# PLANNING BOARD MEETING AGENDA

Thursday April 16, 2020  
Town Hall Meeting Room  
6:30 p.m.

**To:** Berwick Planning Board  
**From:** Lee Jay Feldman  
**Date:** April 16, 2020  
**Re:** CAF Realty Grow Facility Pond Road

**Re: Response and resubmission for CAF Realty Maine, Pond Hill Road**

LANDSCAPE PLAN

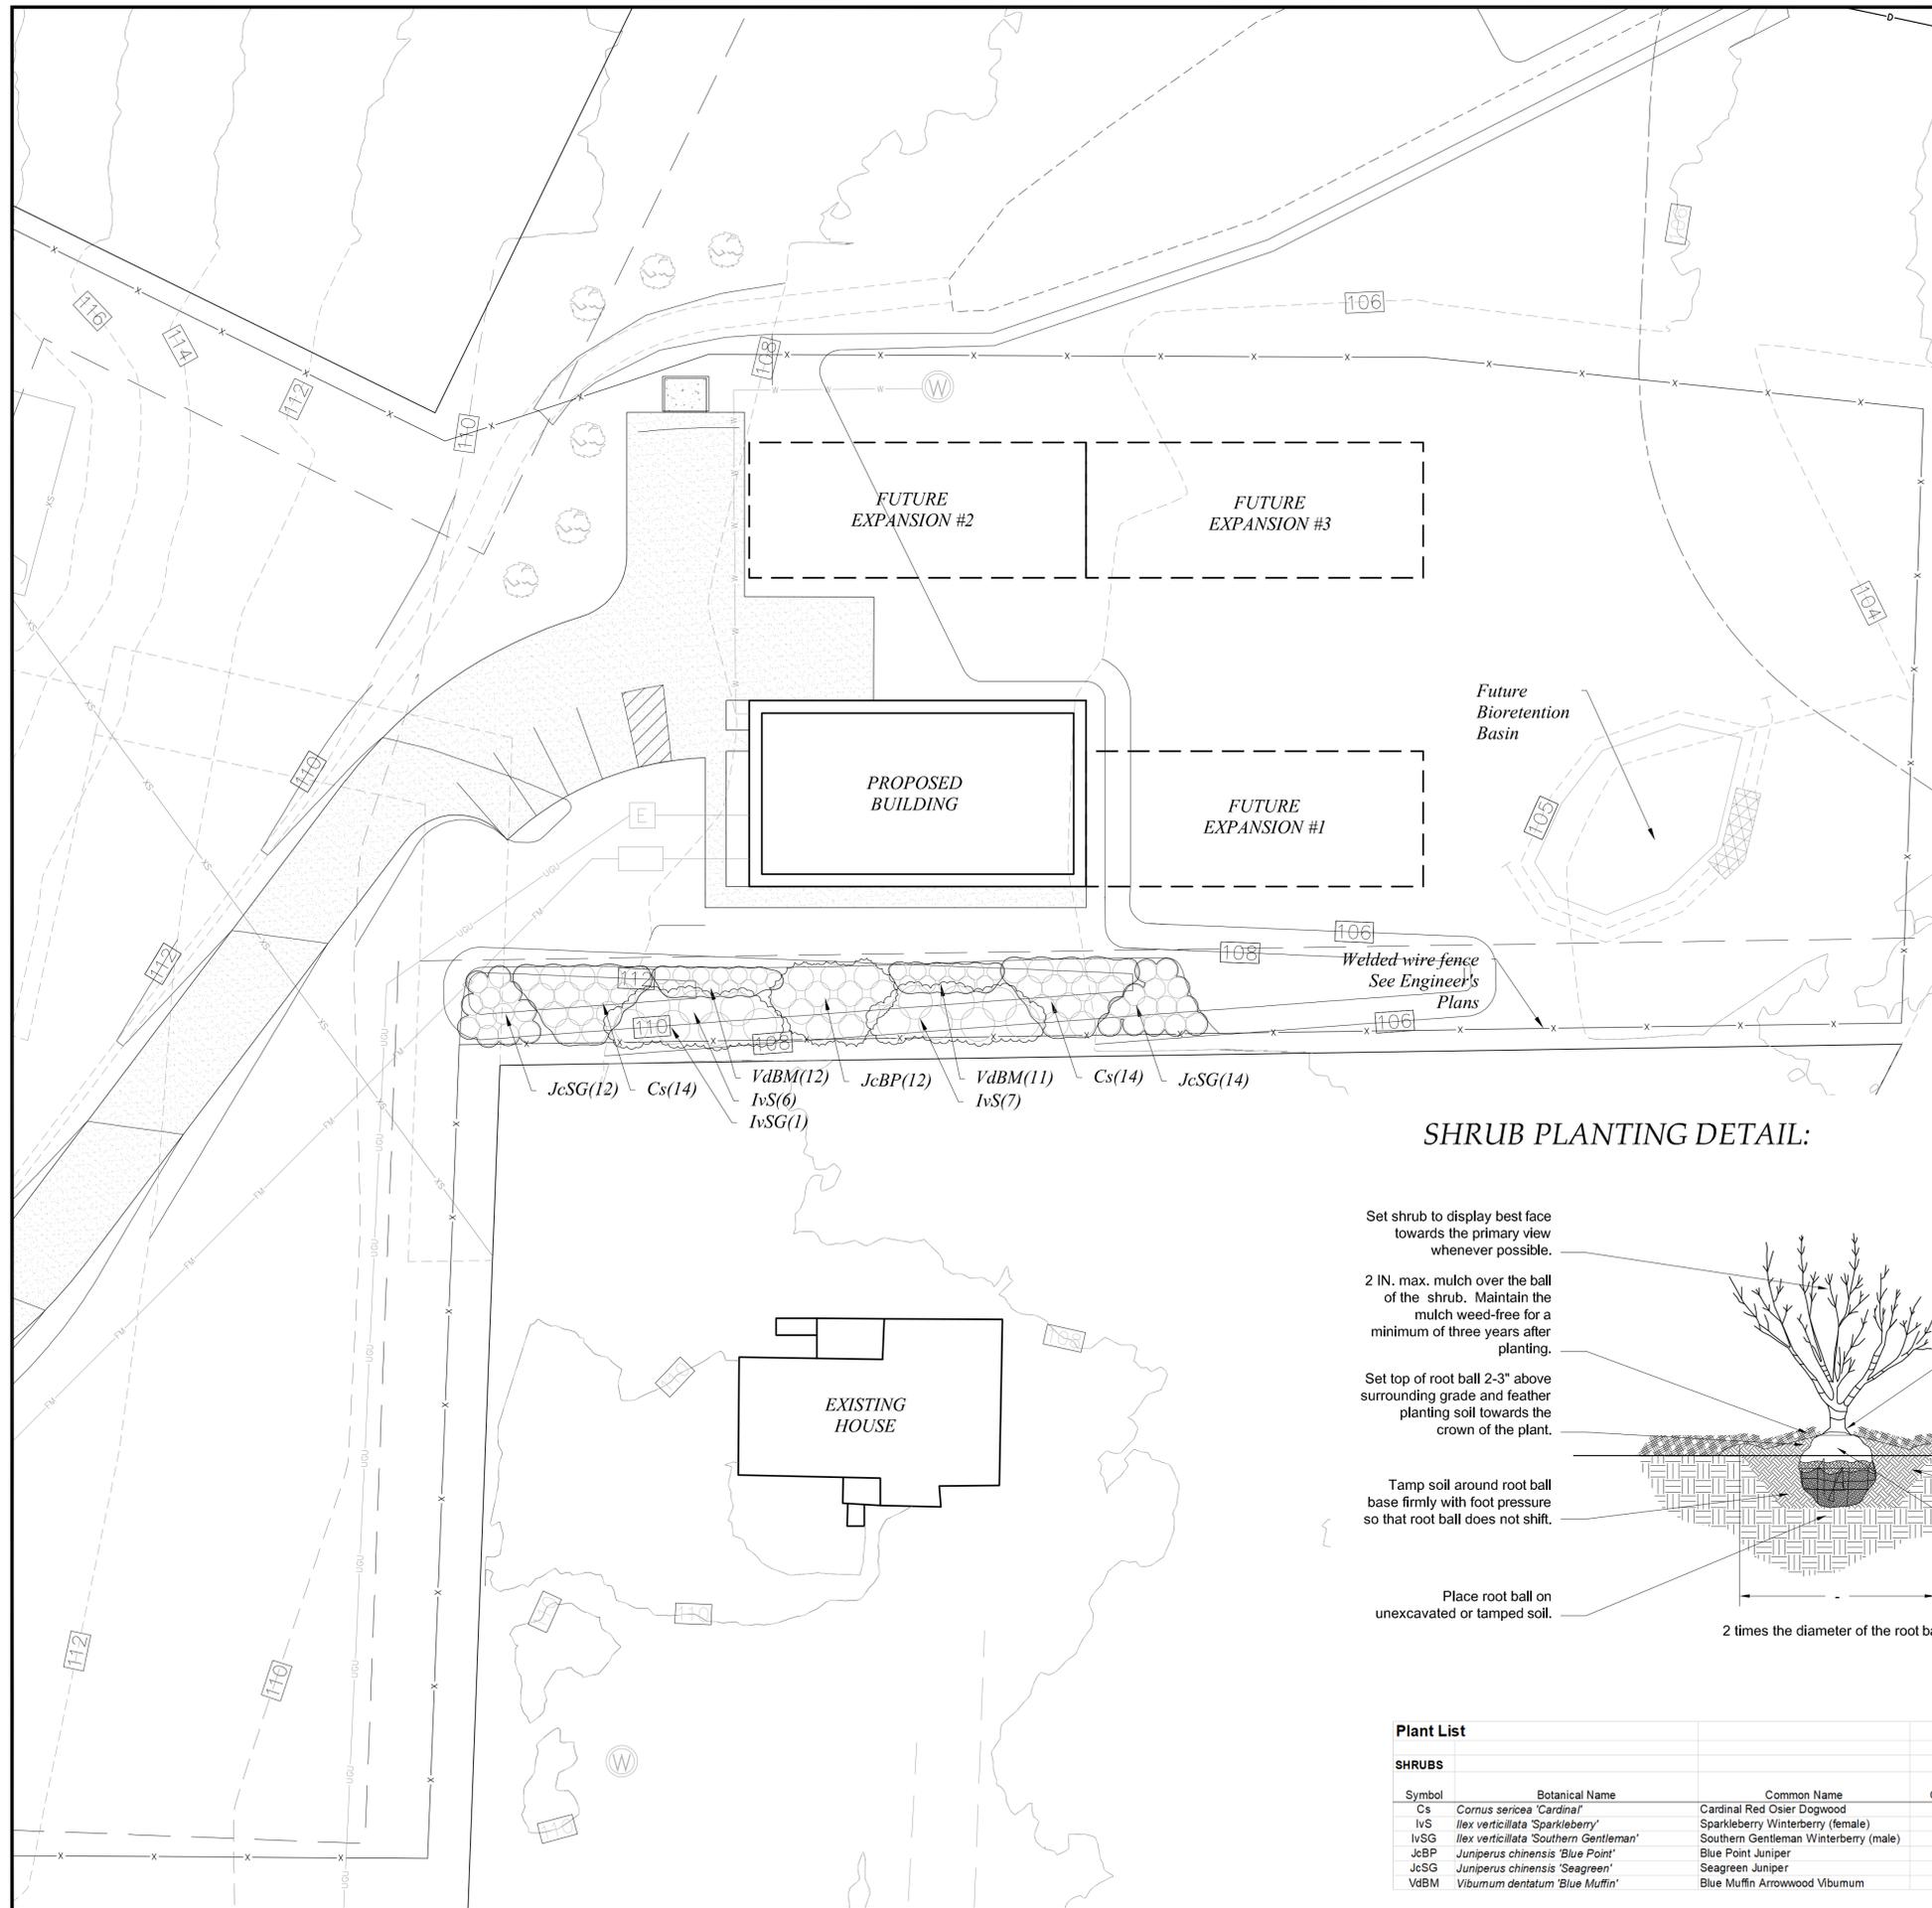
Nichole Fecteau said nine plantings are not sufficient.

NO.	REVISIONS	DATE	INT.
1.	PER REVISED SITE PLAN - BERWICK	4/9/20	LF
0.	INITIAL SUBMISSION TO THE TOWN OF BERWICK	3/13/20	LF

4. The building is intended to have wood siding and a metal roof as depicted. In additiona we have shown a rendering of the building and we are currently updating that with the new plantings and berm as shown on the grading plan and landscape plan. I do not have the new rendering completed but it will be finished tomorrow and will be submitted then.

**GRADING, DRAINAGE, AND UTILITIES PLAN**  
prepared for  
**CAF REALTY MAINE**  
TAX MAP R-70, LOT 16  
11 POND ROAD BERWICK, ME

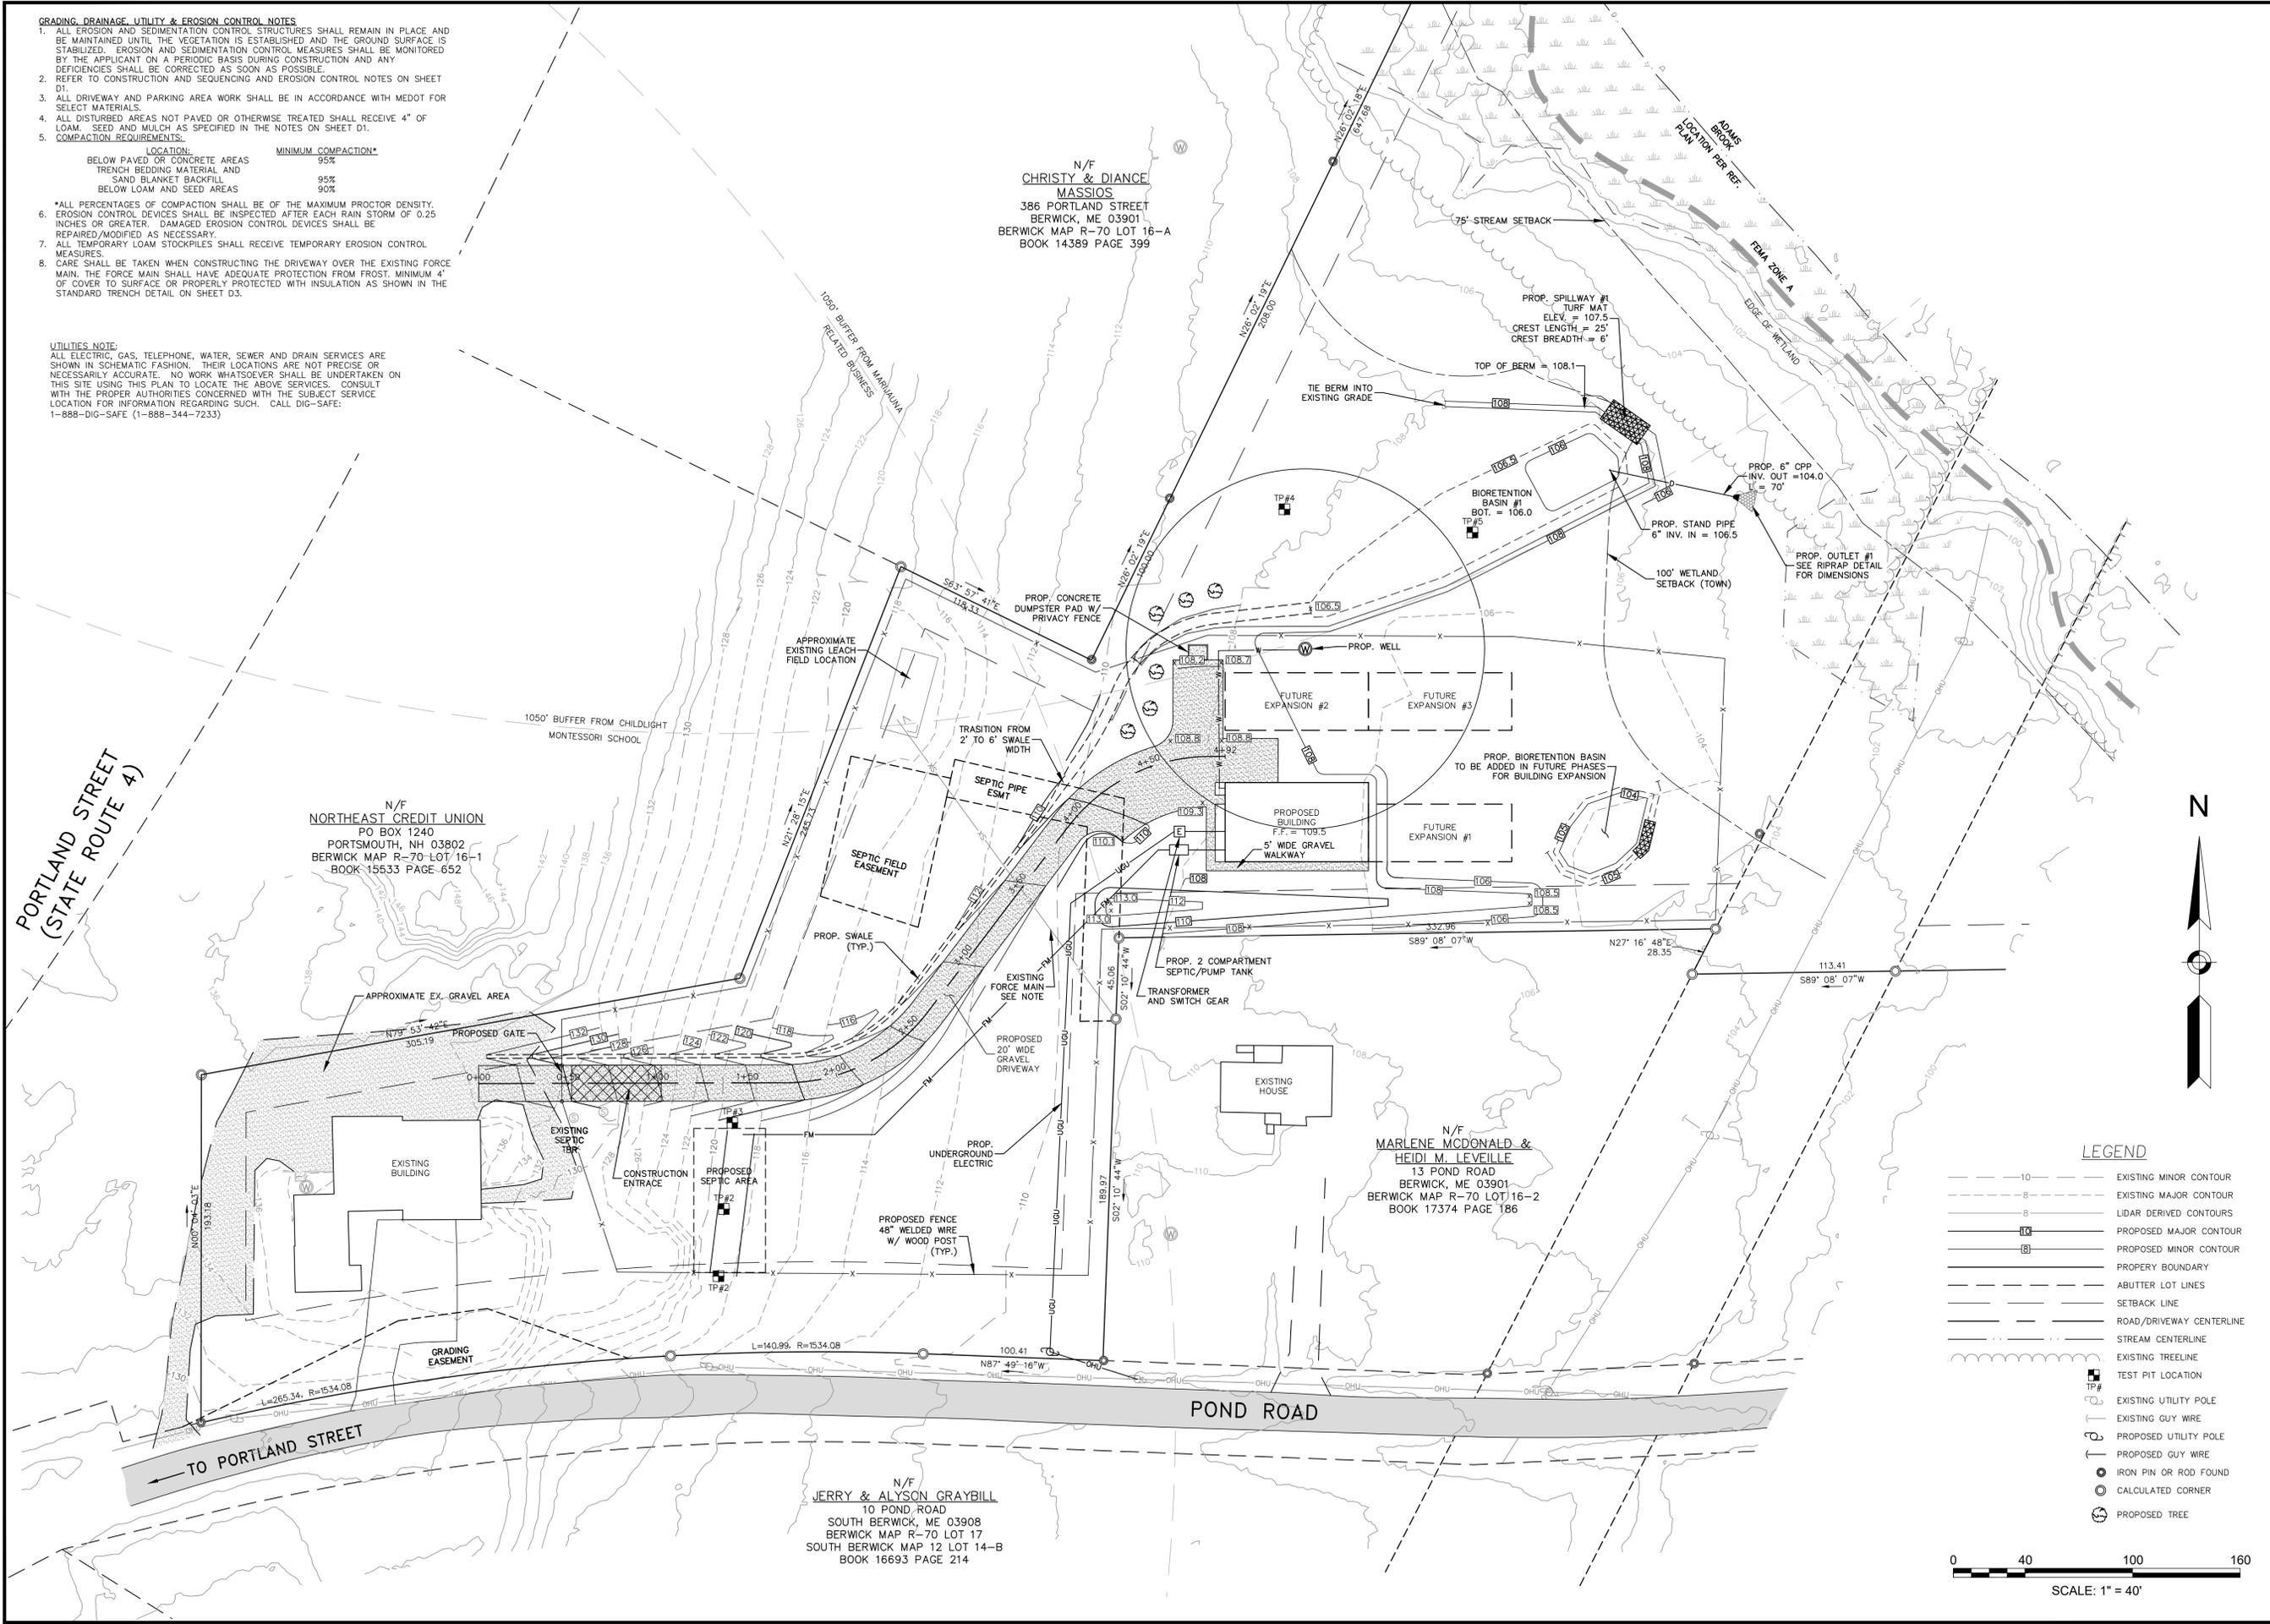
- In the applicant's submittal, they discuss the exhaust system, however, none of the plans indicate where the filtration system is exhausting (which side of the building in relation to the abutter)

NO.	REVISIONS	DATE	INT.
1.	REVISED BERM FOR BARN SCREENING	4/8/20	MCS
0.	INITIAL SUBMISSION TO THE TOWN OF BERWICK	2/5/20	MCS

2. We are not aware of any new daycare and this application was submitted prior to that knowledge.
3. The exhaust for the filtration system will be on the north side of the building.
